**ON-SITE SEWAGE DISPOSAL SYSTEM
HOWARD COUNTY HEALTH DEPARTMENT
BUREAU OF ENVIRONMENTAL HEALTH
3525-H ELLICOTT MILLS DRIVE, ELLICOTT CITY, MD 21043**

03-340833

Fogles Septic Clean, Inc IS PERMITTED TO INSTALL ☒ ALTER ☐
ADDRESS: 580 Obrecht Road, Sykesville PHONE NUMBER: 410-795-5670
SUBDIVISION: Twin Pines LOT NUMBER: 6
ADDRESS: 3 150 Stiles Way PROPERTY OWNER: D.R. Horton
SEPTIC TANK CAPACITY (GALLONS): 1250 OUTLET BAFFLE FILTER REQUIRED ☐
PUMP CHAMBER CAPACITY (GALLONS): N/A COMPARTMENTED TANK REQUIRED ☐
NUMBER OF BEDROOMS: 4
SQUARE FEET PER BEDROOM: 180
LINEAR FEET OF TRENCH REQUIRED: 150 HOUSE SERVED BY PUBLIC WATER ☐

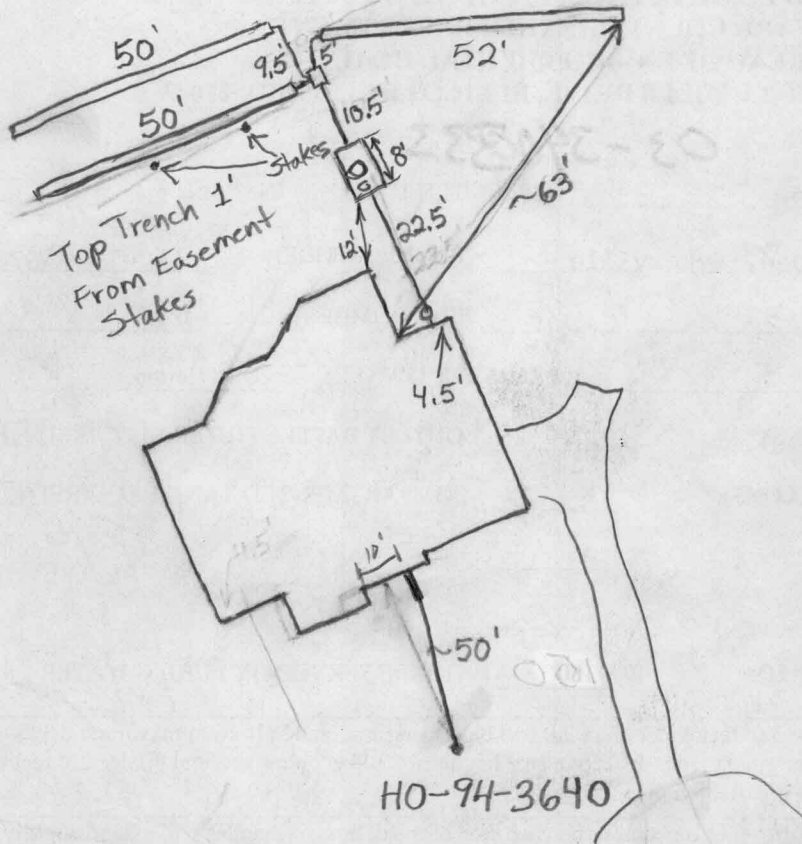
PRE-CONSTRUCTION 7/20/04 Contour off somewhat from B.P. To install 3-50' trenches. (BB)

INSTALLATION 7/20/04 Trenches done. House connection made. Need tank cleanouts. (BB) 7/21/04 - Still needs manhole (EG) 8/2/04 - Manhole & C.O. Installed (EG)
